Access Compliance Report

Public Rights-of-Way

(Curb Ramps)

Intersection ID: 12508	Main Street: BELVEDERE_AV	Cross Street: CLUB_RD	Location: W
ADA ID: 6C0BF9E0197F	Ramp Type: Perp	Initial Pass/Fail: Fail	Overall Compliance: No
Severity Score: 21.25			
Codes/Mitigation Info/Possible Solution		Field Measurements/Component Compliance

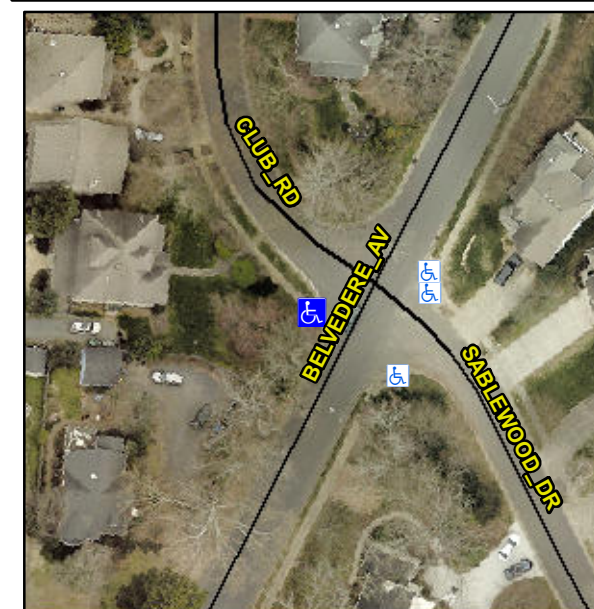
PROW/ADA:

R304.5.1, R304.2.2

Compliance	Description	Data	Compliance	Description	Data
N/A	Ramp Length (in)	67.5	No	Ramp Slope (%)	9.4
No	Ramp Width (in)	46.0	Yes	Ramp XSlope (%)	1.2
N/A	Flare Type LT	N/A	N/A	Flare Type RT	N/A
N/A	Flare Slope LT (%)	N/A	N/A	Flare Slope RT (%)	N/A
N/A	Flare Traversable LT?	N/A	N/A	Flare Traversable RT?	N/A
N/A	Landing Length (in)	N/A	N/A	DWS Provided?	N/A
N/A	Landing Width (in)	N/A	N/A	DWS Contrast?	N/A
N/A	Landing Slope (%)	N/A	N/A	DWS Length (in)	N/A
N/A	Landing X Slope (%)	N/A	N/A	DWS Full Width?	N/A
N/A	Landing Curb? (Y/N)	N/A	N/A	DWS Offset (in)	N/A
N/A	Shared Landing?	N/A			
N/A	Gutter Ponding?	N/A	N/A	Gutter Slope (%)	N/A
N/A	Gutter Lip Ht (in)	1.0	N/A	Gutter X Slope (%)	N/A
N/A	Painted X Walk1?	No	N/A	Painted X Walk2?	N/A
	X Walk 1 Direction	To SE		X Walk 2 Direction	N/A
N/A	X Walk 1 Width (in)	N/A	N/A	X Walk 2 Width (in)	N/A
	X Walk 1 Slope (%)	1.4		X Walk 2 Slope (%)	N/A
	X Walk 1 X Slope (%)	2.2		X Walk 2 X Slope (%)	N/A

Possible Solutions:

Remove & Replace Entire Ramp.
